January 8, 2020

ADDENDUM NUMBER THREE (3)

Project: Replacement Facility for
Tippah County Hospital
Ripley, MS
PN: 18015

FROM: Dean and Dean/Associates Architects, P.A.
4400 Old Canton Road, Suite 200
Jackson, MS 39211
(601) 939-7717

1 PARTIAL FLOOR PLAN – LIGHTING PART D
E201D SCALE: 1/8"=1'-0"

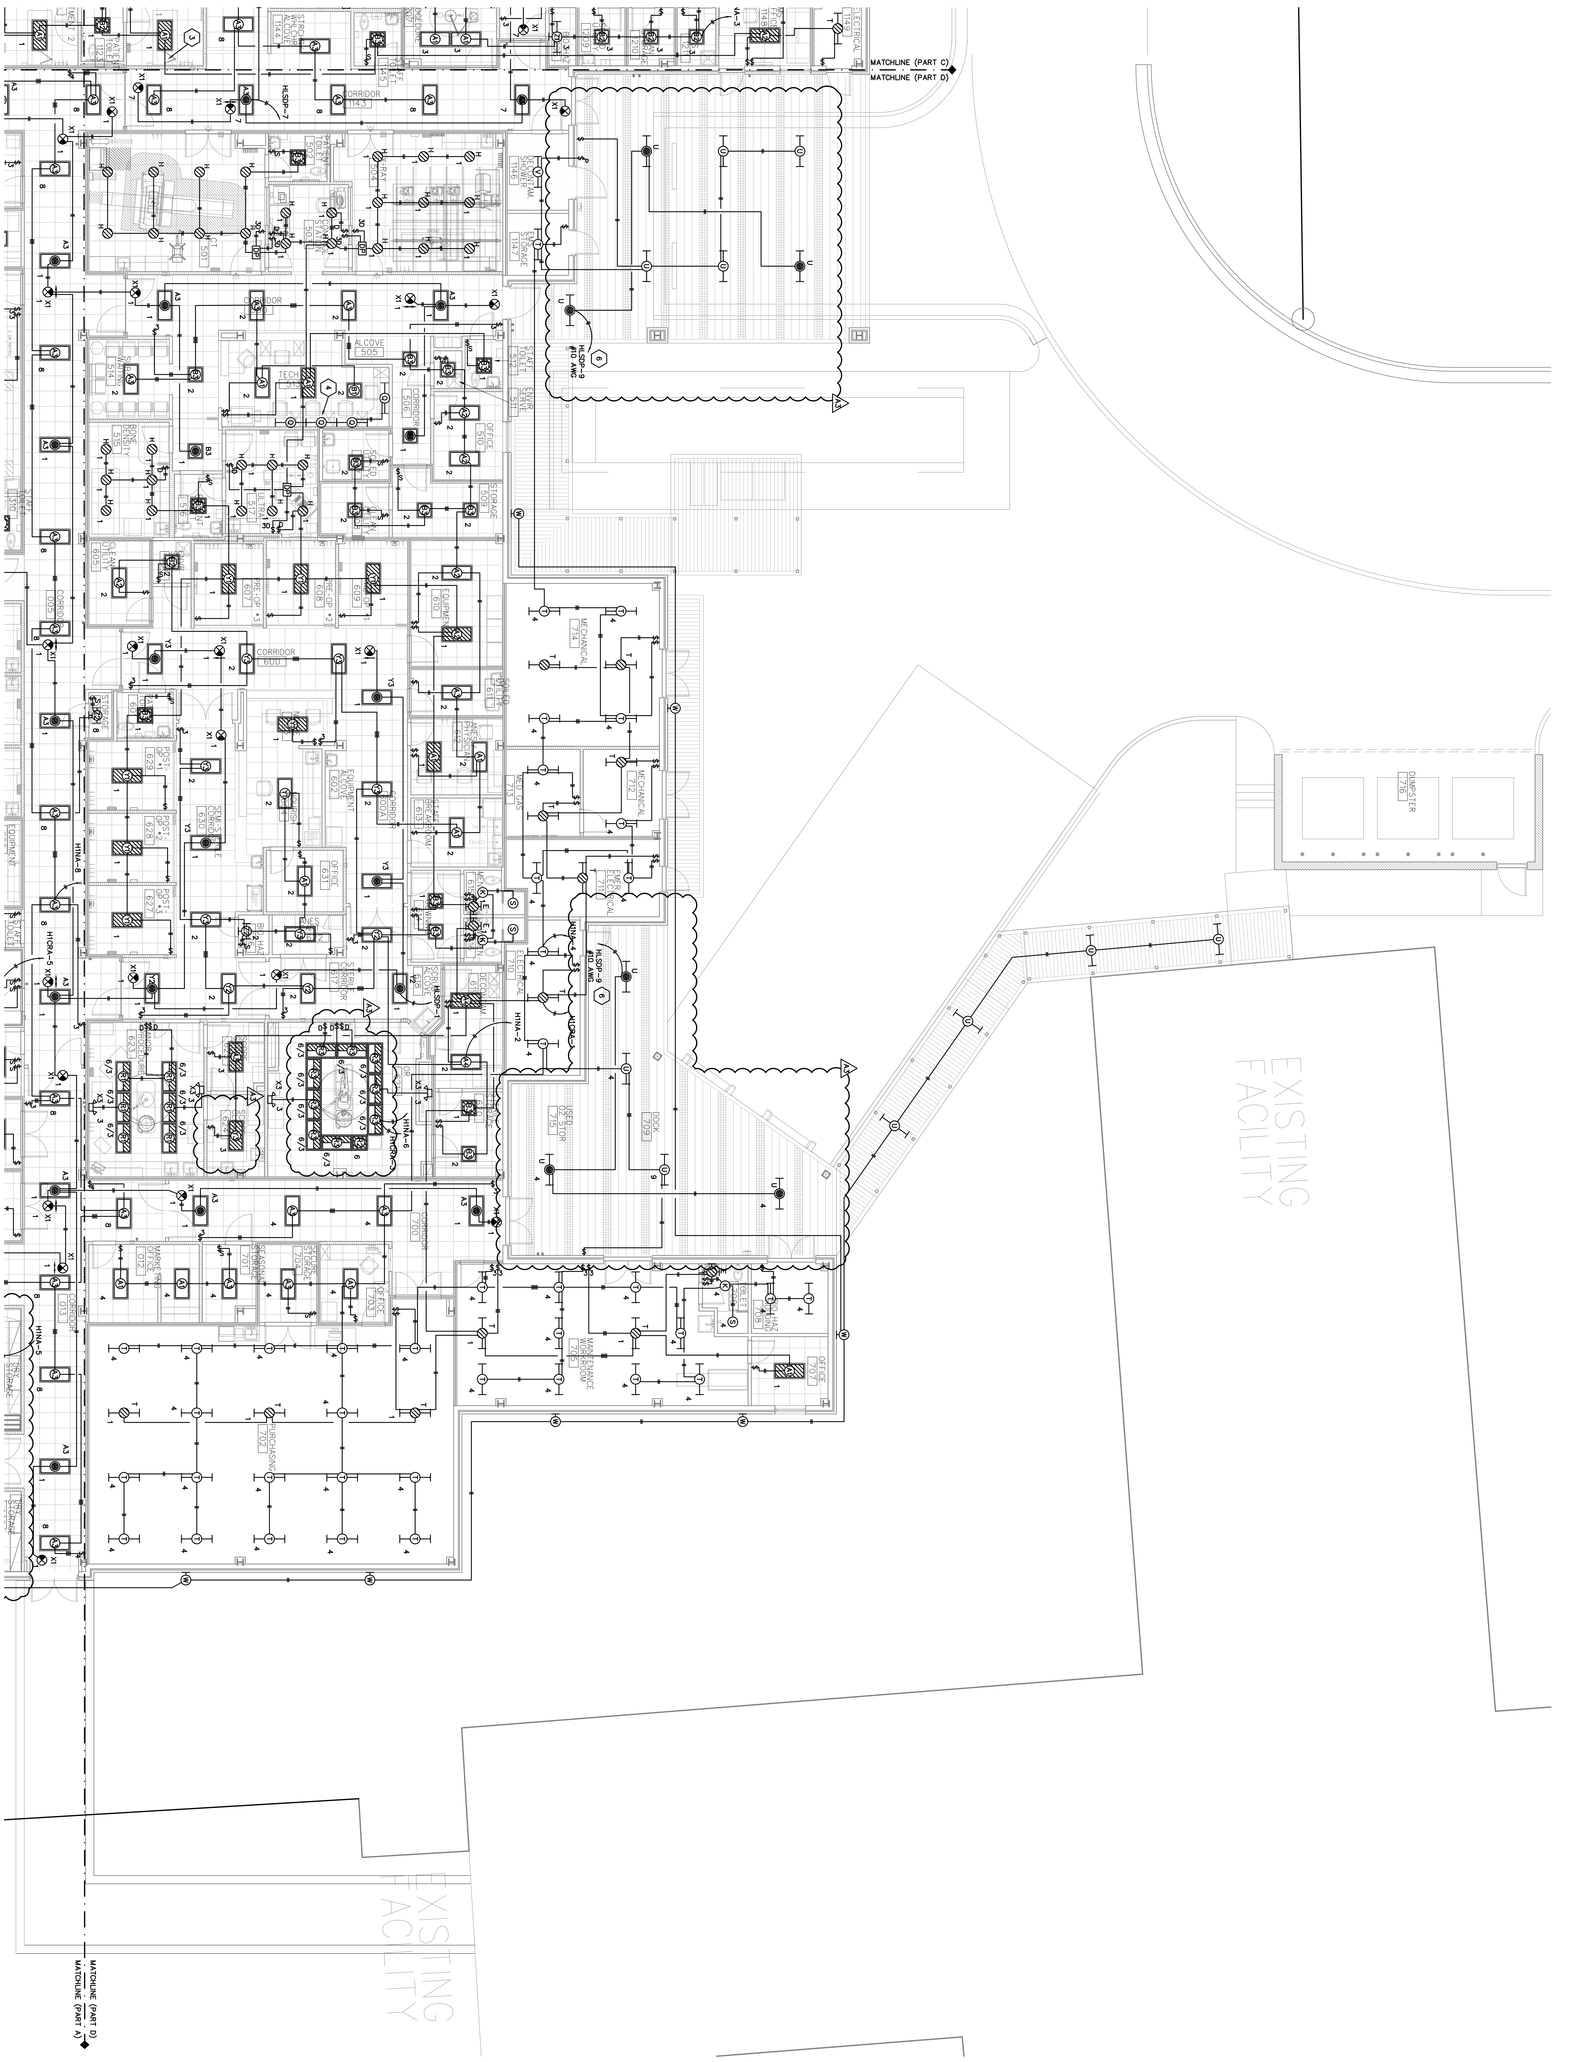
1. The Ambulance Canopy circuits and Loading Dock circuits have been modified to have life safety circuits for egress.

2. The light in OR 621 shall have three drivers, one of which controls a green color light in the fixture. An additional dimmer has been added for control of the green lights.
